Bulletin 0019

FBK 745

Important Fitment Information

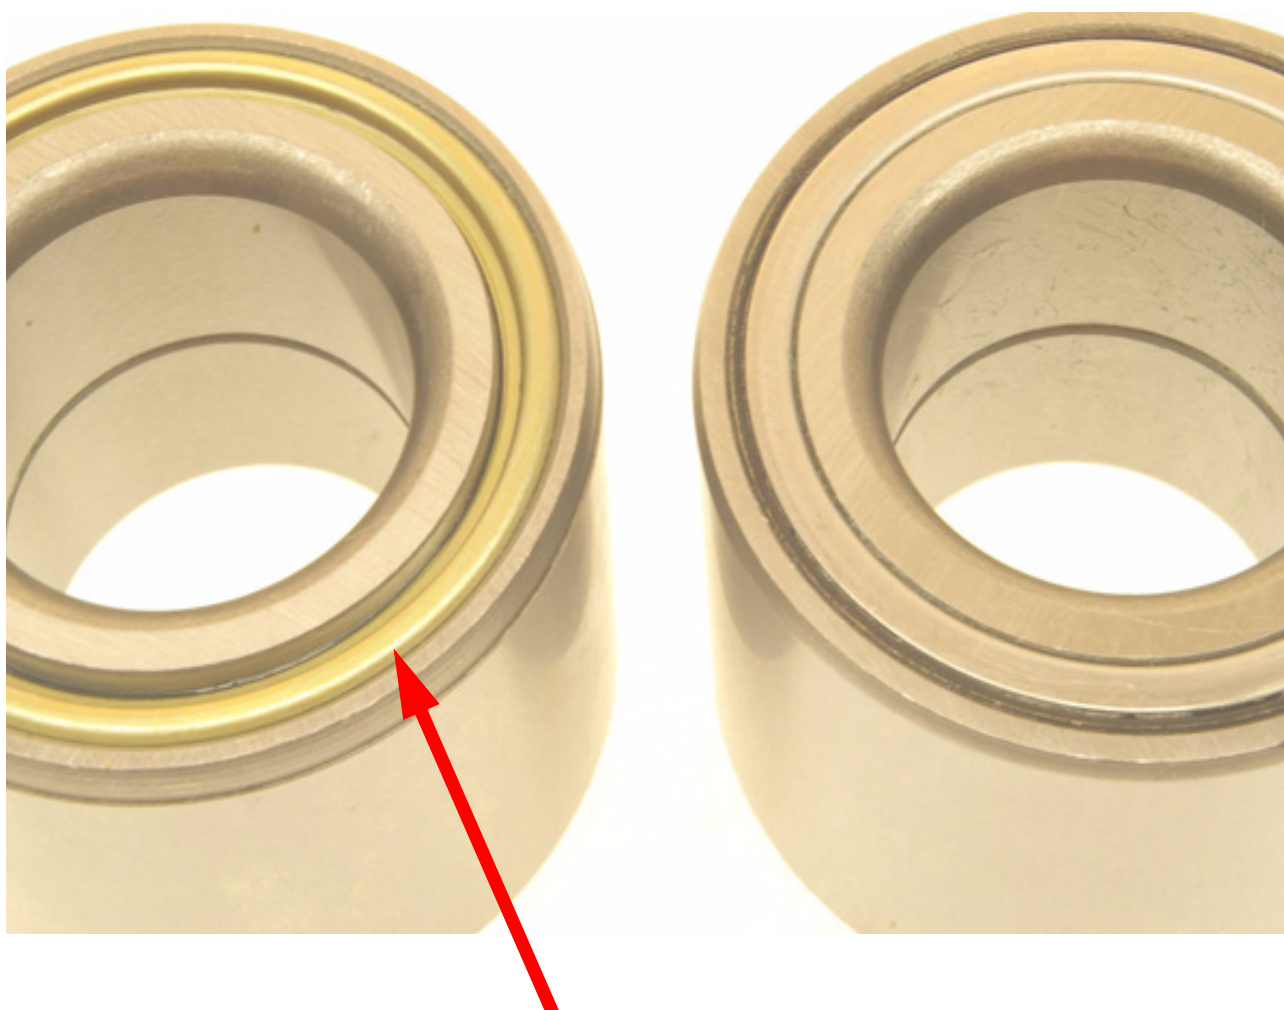
Please note that some examples of this bearing are designed with a different sealing system. If the two end plates are of a different colour then the GOLD side must be fitted inboard (i.e. towards the centre of the vehicle)

Note the Gold colour is an inserted section
